**STAFF REPORT:** 12/13/2023 REGULAR MEETING

**APPLICATION NUMBER:** HDC2023-00144

**ADDRESS:** 2485 BURNS

**SCOPE:** REPAIR AND ENLARGE FRONT PORCH AND WALKWAY

Figure 1, by Applicant: proposed front porch, showing the expansion of the threshold, the top step landing, the porch and the width of the sidewalk.

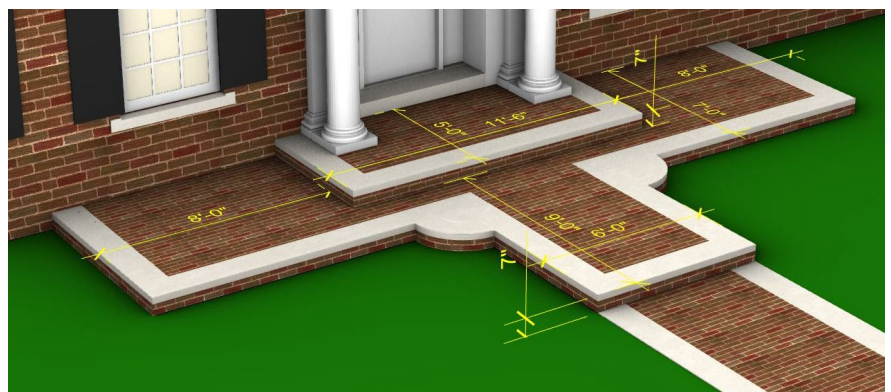
- Turning to the current application, it is staff's opinion that the proposed extension of the threshold stone to meet the exterior façade of the doorway is appropriate. However, staff has the opinion that two additional proposed features greatly alter the historic, character-defining features of the front porch:

- The introduction of brick pavers on the top level of the porch, which greatly alters the simplicity and uniformity of the upper threshold of the porch that supports the columns both physically and visually as one architectural unit. Staff does not have an issue with the expansion of its dimension as proposed if it maintains the limestone surface at this location.
- While the expansion of the lower area of the porch with a brick interior and limestone exterior is appropriate in staff's opinion, the introduction of a "tongue" that extends out into the walkway, alters the character defining feature of the front elevation critical to an understanding of the building's style by introducing a new design element that is historically not appropriate. Staff offers the opinion that the porch expansion maintain a simple rectangular form or, if the

Figure 2, by the Applicant, showing the previously submitted concept design, which was denied by the Commission on August 2023.

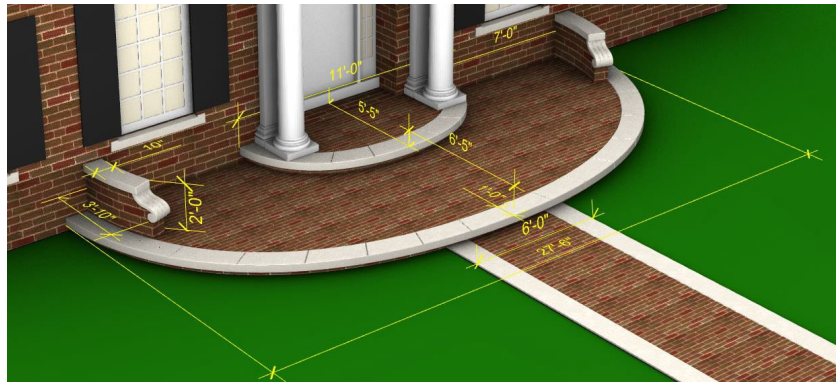
- The Commission’s denial of the August 2023 application was for the following reasons:

- The proposed replacement of cast stone and limestone stone decking of the porch, by introducing concrete pavers and new limestone in a circular form destroys historic distinctive character defining features of the classically inspired building.
- The introduction of wingwalls adds a new element that obscures and diminishes the distinctive, character-defining features of the Georgian Revival architecture.
- The expansion of the scale of the

lower step and sidewalk are at a scale and width that diminishes the proportions of the approach and entrance to the building, thereby breaking the composition and complexity of the façade

elements by over-extending the modest foundation that supports these character-defining features of the entrance.

- Concrete pavers are not an appropriate substitute to clay-fired brick pavers in the Indian Village Historic District.
- However, the Commissioners also offered suggestions during the August 2023 meeting that suggested the following guidelines for any changes to the front porch:

- The rectilinear geometry of the front porch be maintained, rather than a circular form introduced.
- The lower step could be expanded, but the upper step (porch decking) be maintained.
- Limestone and brick would be appropriate materials, rather than concrete pavers.
- The balustrade (or wingwalls) added to the porch interrupts the architecture of the house and is not appropriate.

Figure 3, by Applicant: proposed front porch, showing the expansion of the threshold, the top step landing, the porch, and the width of the sidewalk. Note staff's red dashed line, which is the recommendation for the limits of the lower porch expansion.

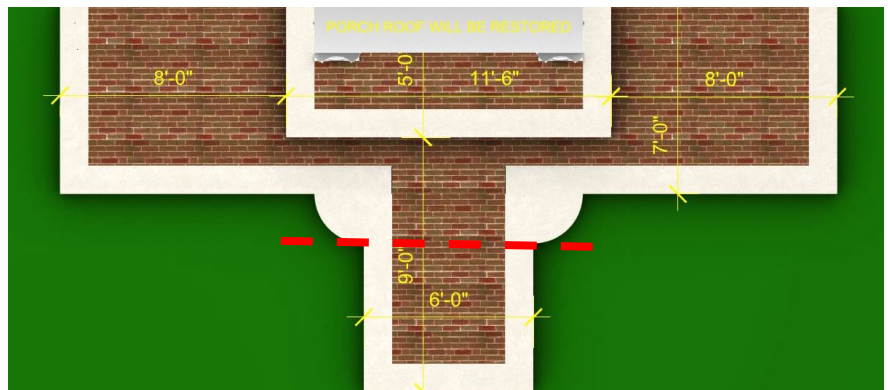
Commission consents to the introduction of the two quarter-round limestone blocks, that this point is the terminus of the porch extension. (See staff's drawn red line in Figure 2).

- Staff offers the opinion that the expansion of the existing concrete walkway from a 4' approximate width to a 6' width, with a white limestone (1' foot on either side) is another expansion of scale that reduces the significance of the front porch by calling more attention to the expansive walkway and therefore is not appropriate. A modest increase in width, by 1 foot (5' maximum), with brick or concrete and without the limestone edge, could be appropriate.

- The upper step consists only limestone capping, as historically shown.
- The applicant provides HDC staff with an updated site plan that shows the front porch lower deck has a rectangular shape or projects no further than the outer edge of the proposed quarter-round limestone blocks, not protruded out into the sidewalk.
- The applicant provides HDC staff with an updated site plan that shows the walkway is expanded no more than 5' and consists of one material, such as clay-fired brick or concrete.
